Korea JTC1/SC2, Committee on Character Codes

Date: 2009.11.20

Status: National Body Position, Rep. of KOREA

Subject: A solution proposed by R.O. Korea for incorrectly mapped comptb. chars

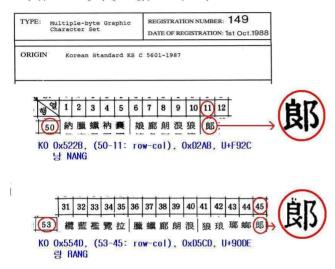
- T20. pp. 1213 and 1215; CJKC_SR.txt
- T20.1 p 1213: We request to change the glyph for U+F92C as shown below:
- We need to add one more stroke (i.e., The number of strokes need to be changed from 10 to 11).

T20.2 p. 1215; We request to change two lines as shown below:

T20, 2, 1) Change 90CE to 90DE

T20.2.2) Change glyphs of two Hanja characters from 10 strokes to 11 strokes.

T20.3 We request to change one line in CJKC_SR.txt file as shown below:

OF92C; 090CE;;;; K0-522B;;

OF92C; 090DE;;;; K0-522B;;

Not accepted

The glyph as currently shown in the chart is correctly mapped to 90CE. If the glyph is changed to what the NB of Korea is requesting, clearly it invalidates the compatibility mapping which cannot be changed for reasons given in the disposition of comment T19.1.

At the same time, the Korean NB is making a good case that the source reference K0-522B has a different glyph than the one shown for F92C (see rationale below).

Instead of changing both the glyph and the mapping, at which point it may be argued that none of the current identity of the character is left, it may be better to use variation sequences to fix this situation.
